BRITISH COLUMBIA TIMBER SALES, CHINOOK BUSINESS AREA

PHASE 3 REVIEW OF TSL A94817
BLOCKS G043B4SG & G043C3ZP
ROBERTS CREEK AND STEPHENS CREEK WATERSHEDS

Polar File: 740202
BCTS Contract: 10005-40/PD21TBF001
FINAL REPORT
DECEMBER 2023

Re: Phase 3 Review of TSL A94817 in Roberts Creek and Stephens Creek Watersheds

FIGURE 1.4 Harvest plan map for TSL A94817, block G043C3ZP (as of December 7, 2023). Map source: BCTS.

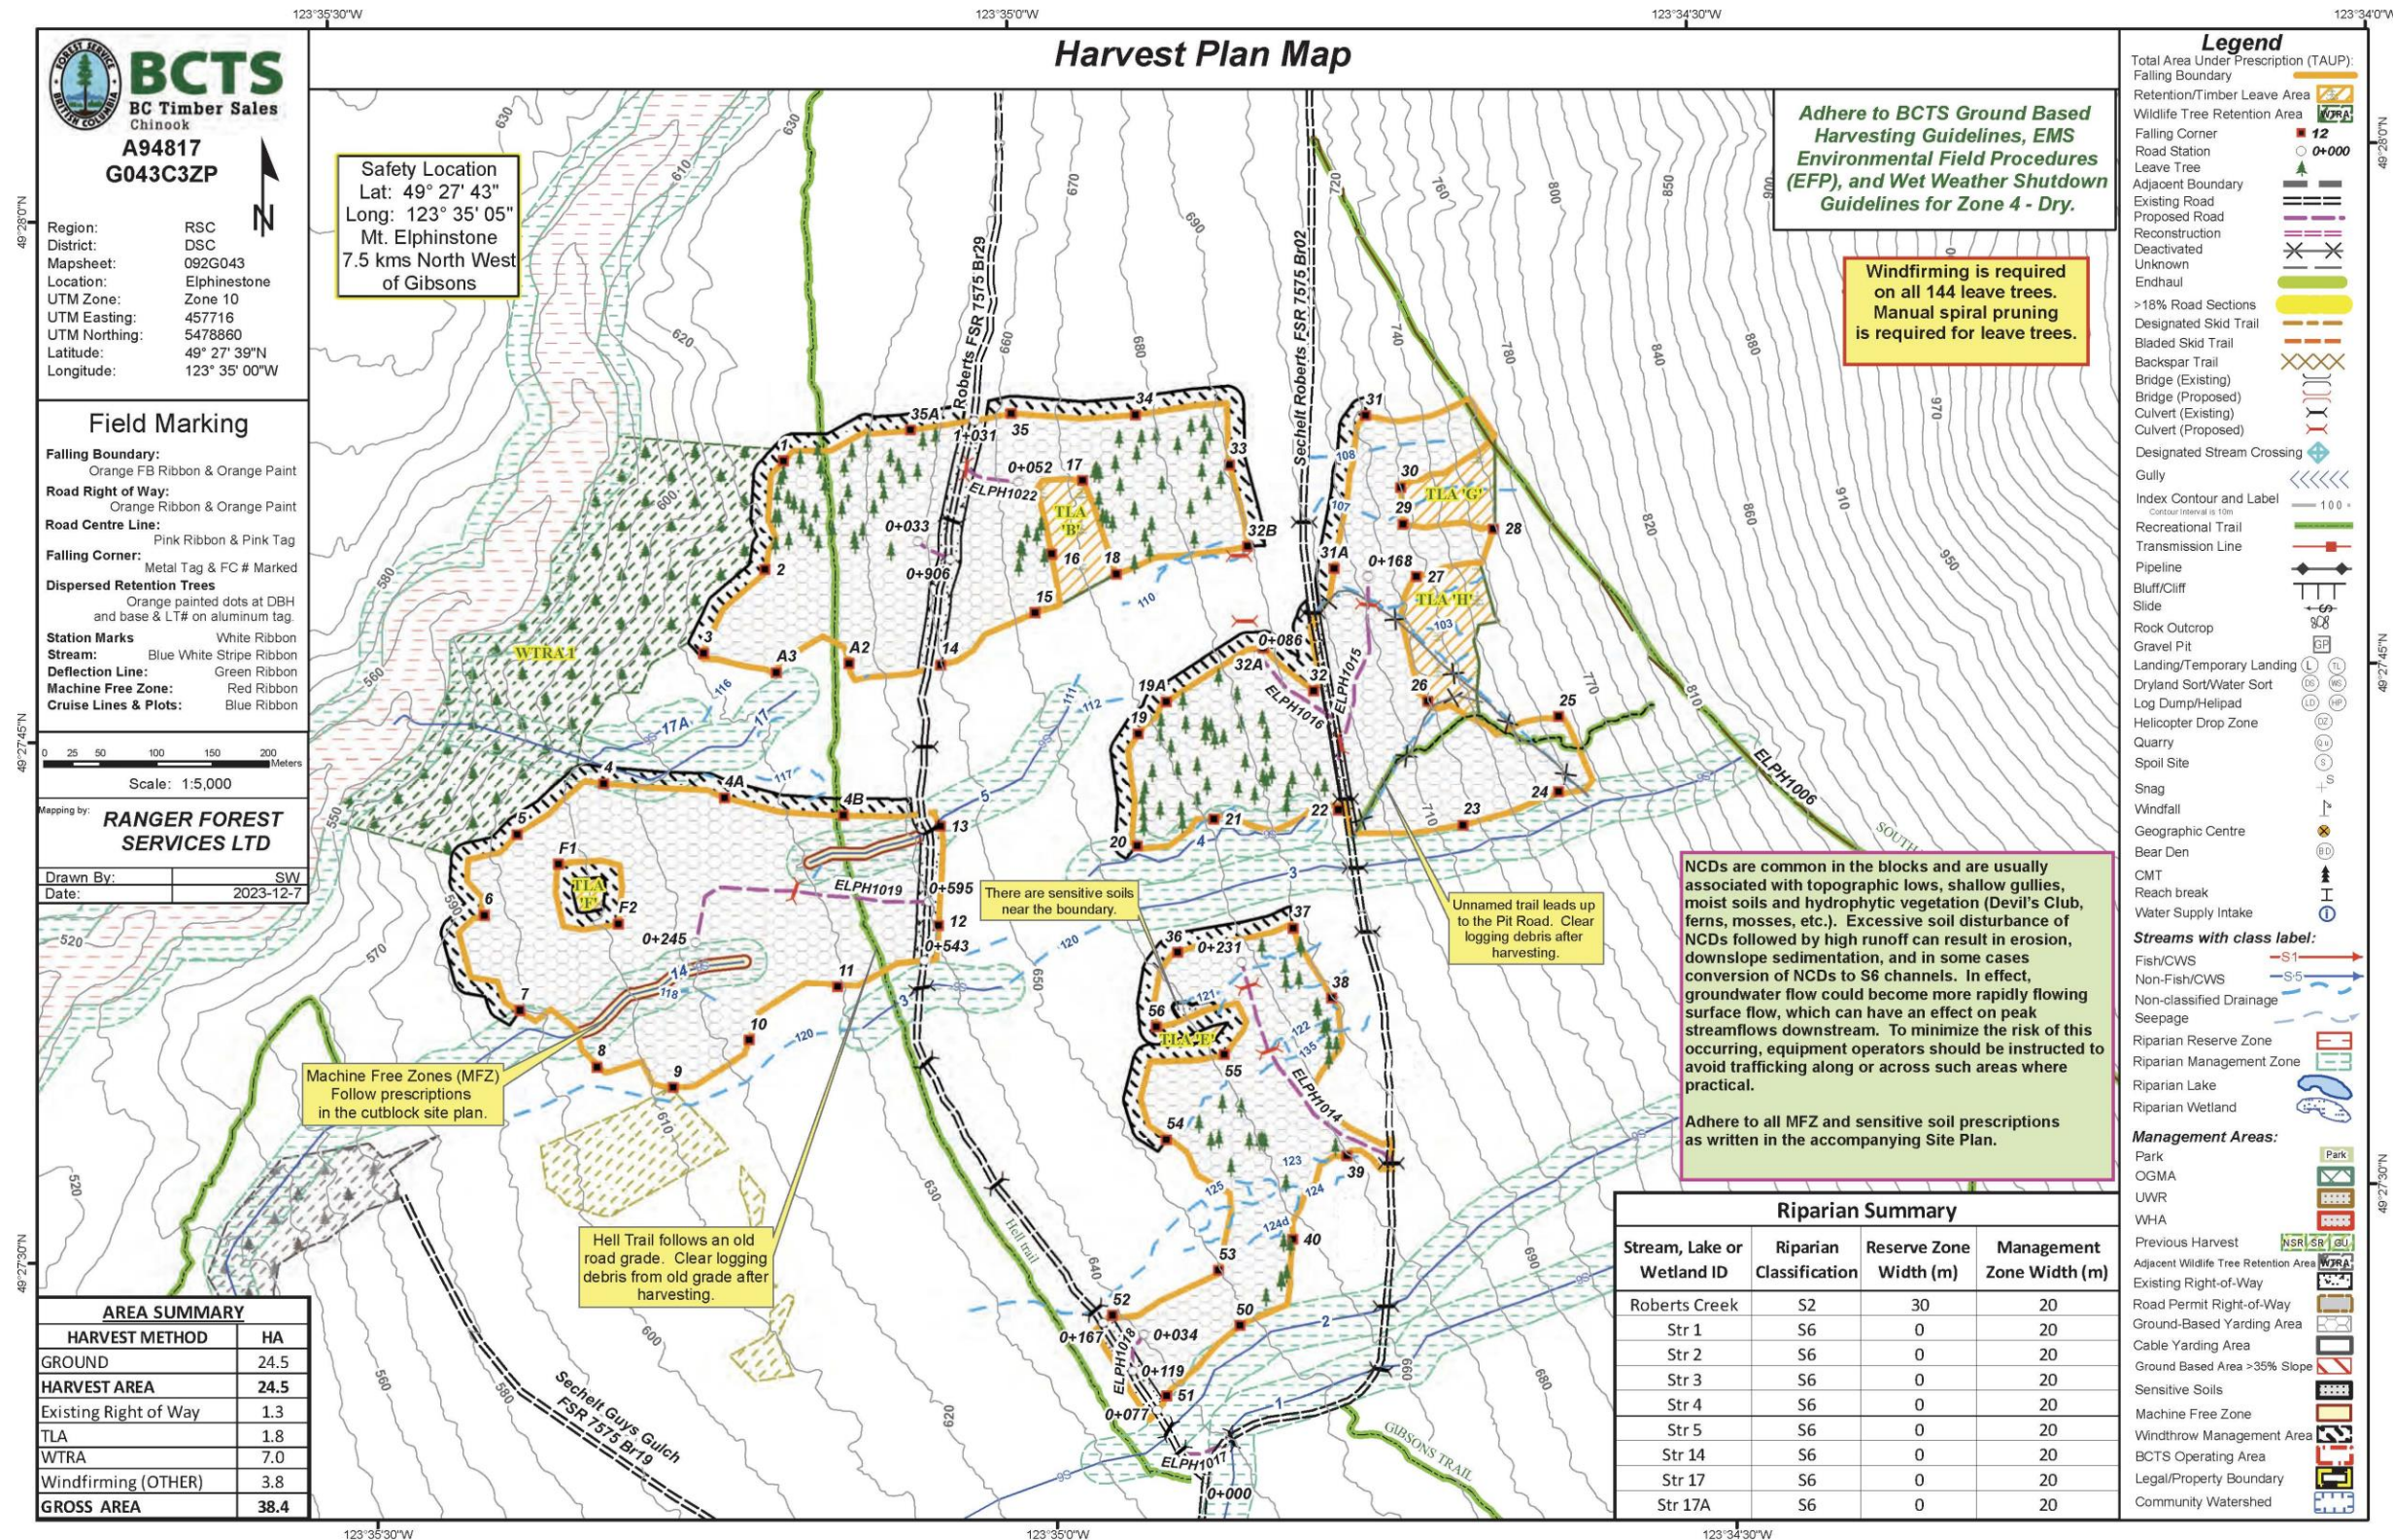
In response to our recommendations on the August 2022 site plan (noted in Section 4.0), BCTS further refined its plans to better align with the Phase 1 and 2 recommendations outlined in Polar (2023). The following summarizes these changes presented on FIGURES 1.3 and 1.4.

For the conservation of summer low flows, Polar (2023) recommends limiting net opening sizes in each block to less than 8 ha. The December 2023 harvest plans include three openings of planned block G043B4SG ranging from 1.62 ha to 6.11 ha, and four openings for planned block G043C3ZP ranging from 4.52 ha to 7.56 ha. Each opening has also been separated by a minimum distance of 2 tree heights in order to buffer each opening from wind and solar radiation. Further, 144 leave trees have been field marked and flagged in each block, which will be subject to windfirming.
